Access Compliance Report

(Curb Ramps)

Intersection ID: 22027	Main Street: CAMBRIDGE CRESCENT DR	Cross Street: CARMEL CRESCENT DR	Location: W
ADA ID: E5182445BC26	Ramp Type: PerpDiag	Initial Pass/Fail: Pass	Overall Compliance: No
Severity Score: 22.75			
Codes/Mitigation Info/Possible Solution		Field Measurements/Component Compliance

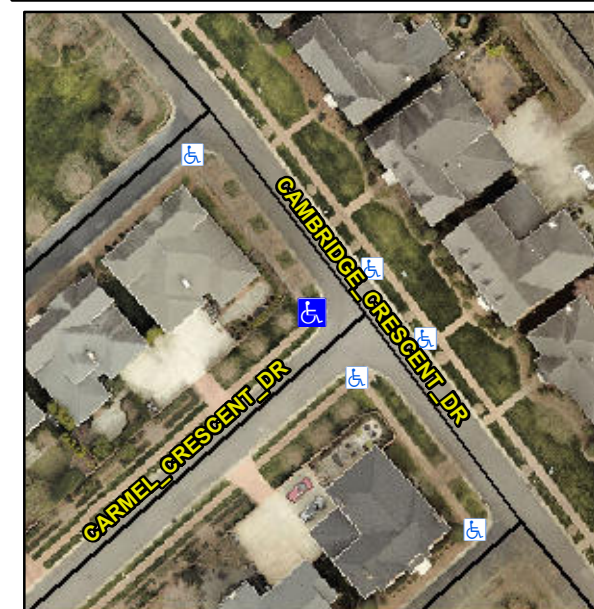
Not Found, R304.5.3, R304.2.2-Perp, R304.3.2-Para, R305, R302.7.2, R304.5.4

Compliance	Description	Data	Compliance	Description	Data
N/A	Ramp Length (in)	71.0	Yes	Ramp Slope (%)	7.3
Yes	Ramp Width (in)	48.0	No	Ramp XSlope (%)	4.6
N/A	Flare Type LT	None	N/A	Flare Type RT	N/A
N/A	Flare Slope LT (%)	N/A	N/A	Flare Slope RT (%)	N/A
N/A	Flare Traversable LT?	N/A	N/A	Flare Traversable RT?	N/A
Yes	Landing Length (in)	49.0	No	DWS Provided?	No
Yes	Landing Width (in)	48.0	N/A	DWS Contrast?	No
No	Landing Slope (%)	3.3	N/A	DWS Length (in)	N/A
No	Landing X Slope (%)	2.8	N/A	DWS Full Width?	No
N/A	Landing Curb? (Y/N)	No	N/A	DWS Offset (in)	N/A
N/A	Shared Landing?	No			
Yes	Gutter Ponding?	No	No	Gutter Slope (%)	5.8
No	Gutter Lip Ht (in)	0.5	Yes	Gutter X Slope (%)	1.1
N/A	Painted X Walk1?	No	N/A	Painted X Walk2?	No
	X Walk 1 Direction	To SE		X Walk 2 Direction	To NE
N/A	X Walk 1 Width (in)	N/A	N/A	X Walk 2 Width (in)	N/A
	X Walk 1 Slope (%)	0.4		X Walk 2 Slope (%)	1.1
	X Walk 1 X Slope (%)	0.9		X Walk 2 X Slope (%)	2.4

Remove & Replace Curb Ramp With Two New Directional Ramps or Equivalent. Remove & Replace Gutter.
